**ADDENDUM No. 2 to the  
14 October 2005 Draft Additional Remedial Investigation Work Plan  
160-Acre Parcel, Rialto, California  
7 December 2005**

**ADJUSTMENT TO MONITORING WELL LOCATION PW-8**

**Figure A [revised]**  
**PROPOSED GROUNDWATER**  
**LEVEL GAUGING AND / OR**  
**SAMPLING LOCATIONS**  
 Rialto, California

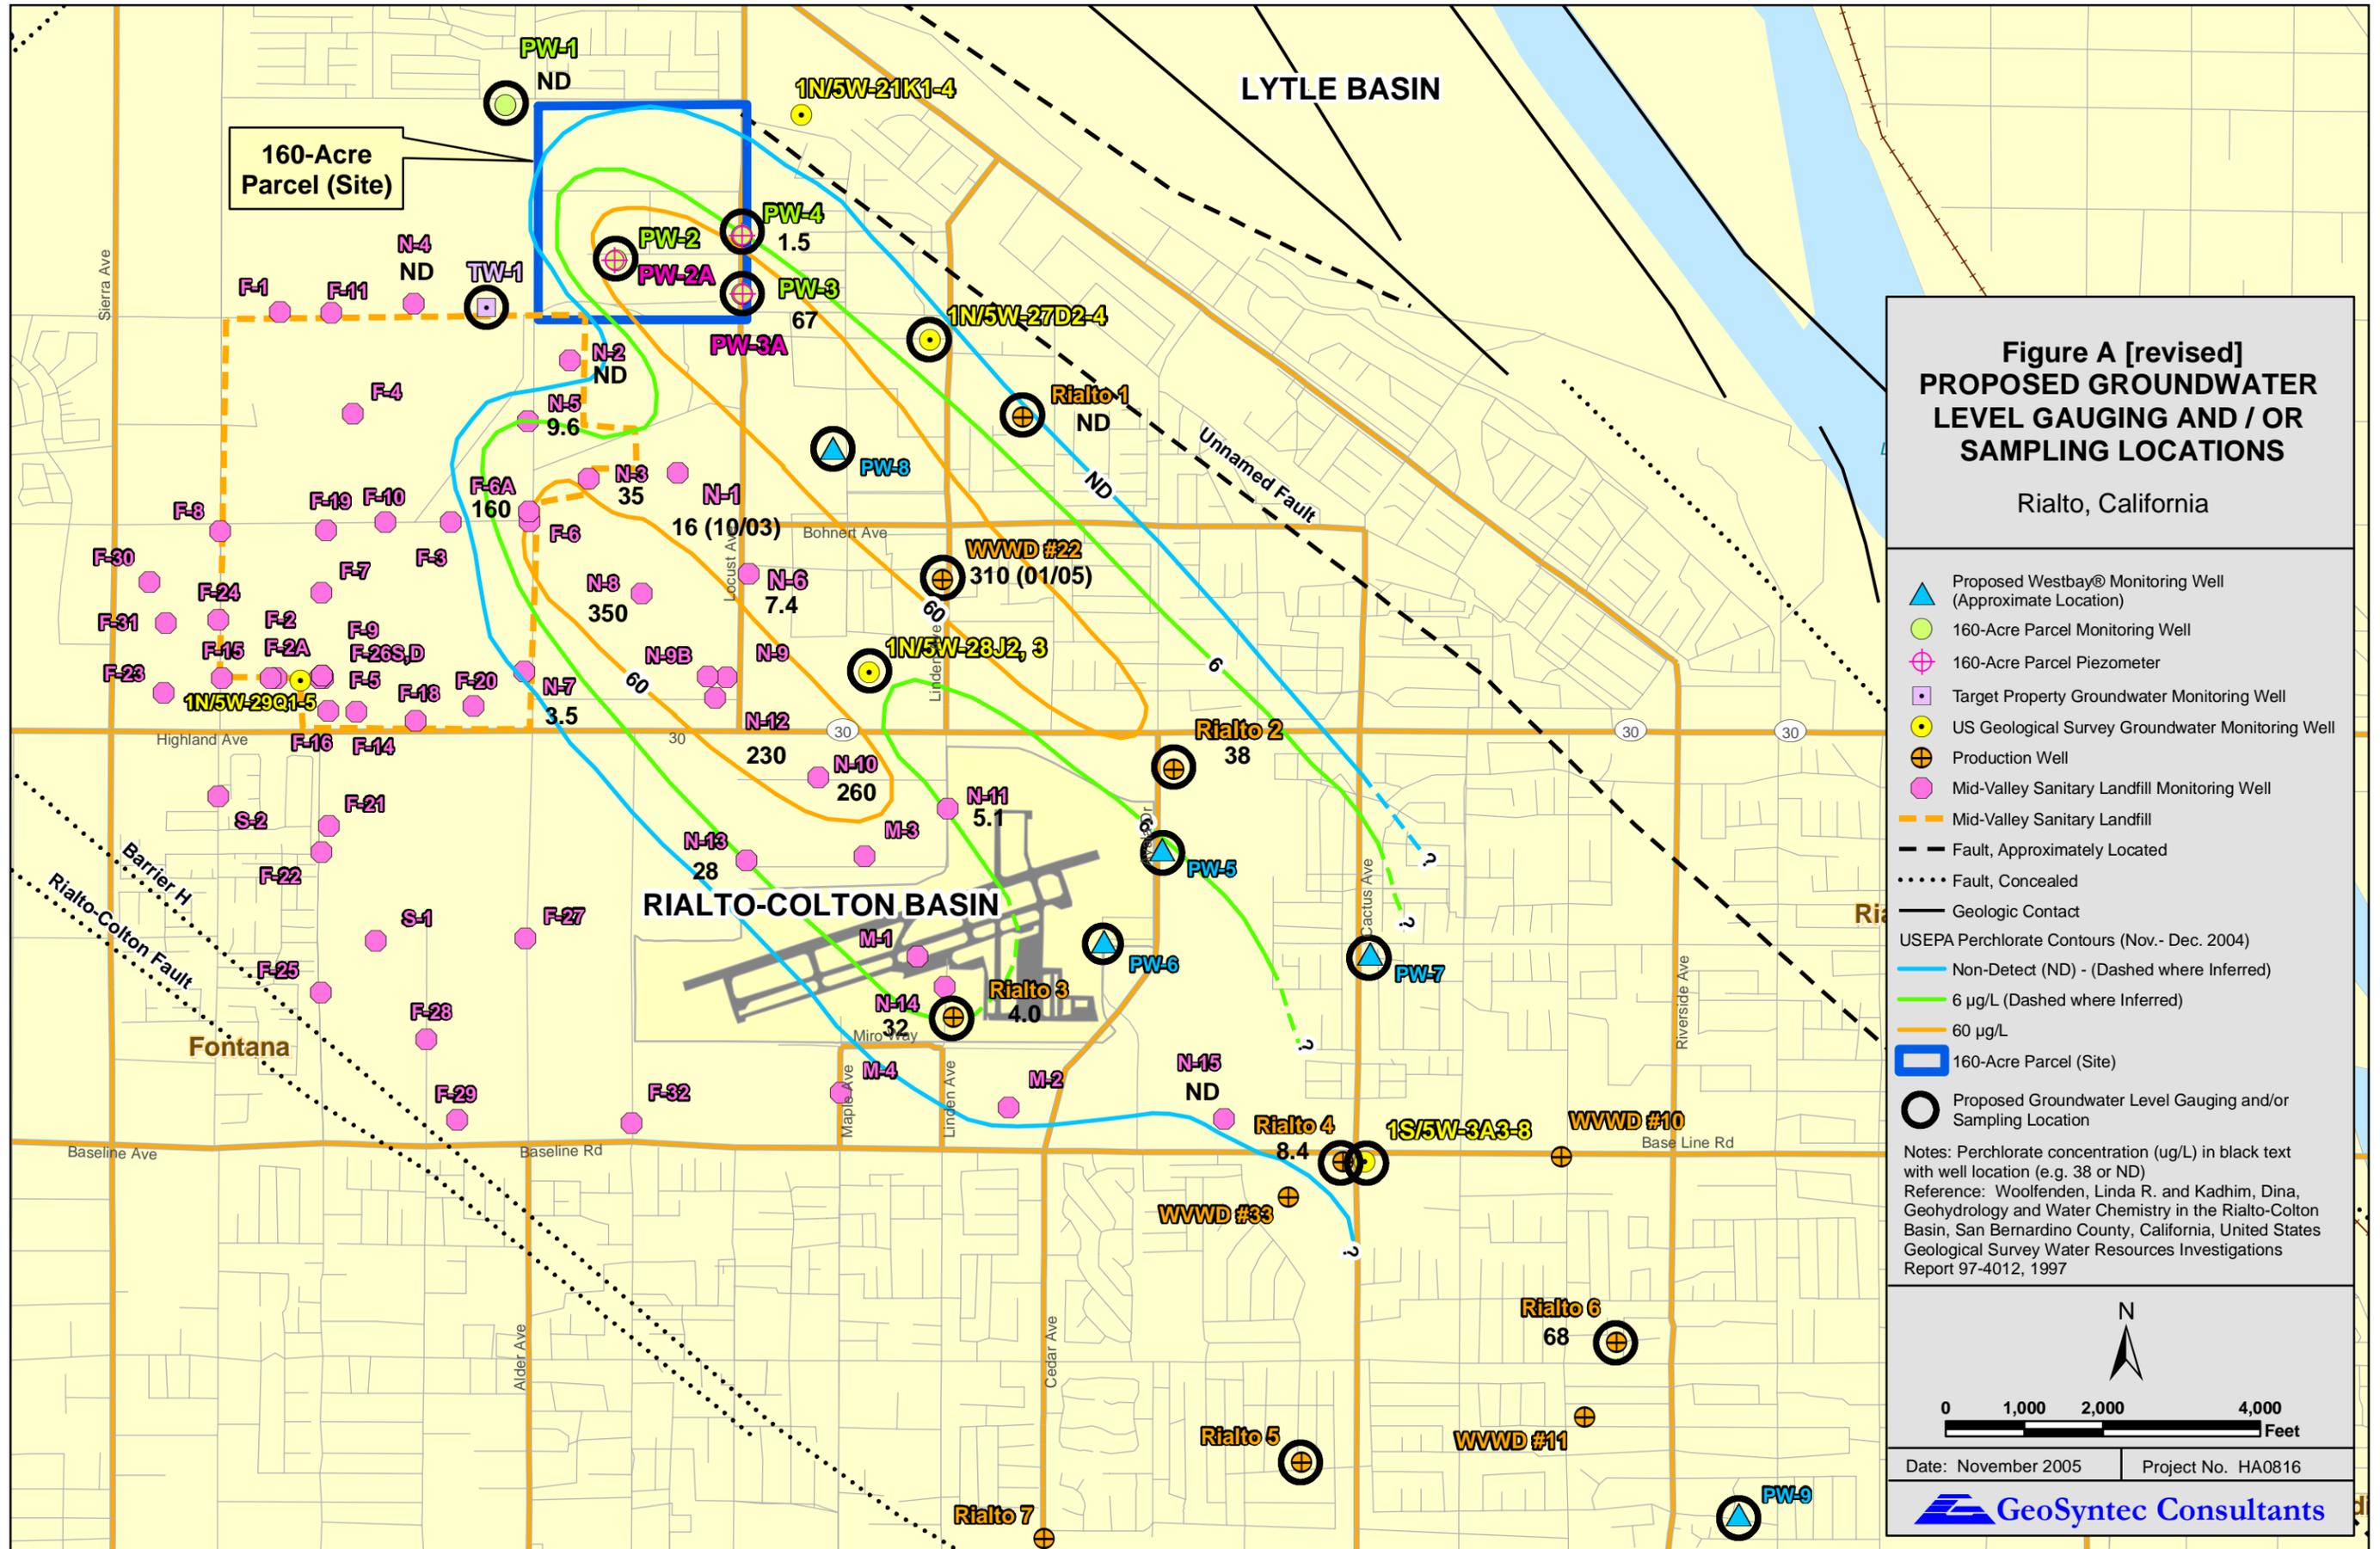
Pursuant to a request from the Regional Water Quality Control Board, Santa Ana Region (RWQCB), Goodrich has agreed to move the location of groundwater monitoring well PW-8 from the previously proposed location near production well Rialto #4 to a location further upgradient, near the intersection of Maple Avenue and Buxton Avenue (Figure A [revised]). This revised well location is subject to the ability to gain access, which has not been confirmed.

The location of monitoring well PW-8 is being adjusted because the United States Geological Survey (USGS) recently installed a cluster of five monitoring wells, screened at various depths, in a location which apparently is similar to that originally planned for monitoring well PW-8. USGS has indicated that the wells in the cluster were sampled during the week of 28 November 2005 for perchlorate and volatile organic compounds (VOCs) and that the results, as well as boring logs and well construction information, will be made available to Goodrich and the RWQCB in a timely manner.

The revised location of monitoring well PW-8 will allow for the assessment of hydrogeologic conditions and perchlorate and VOC concentrations in the area between the 160-acre parcel and West Valley Water District well #22, which has had detections of perchlorate and TCE.
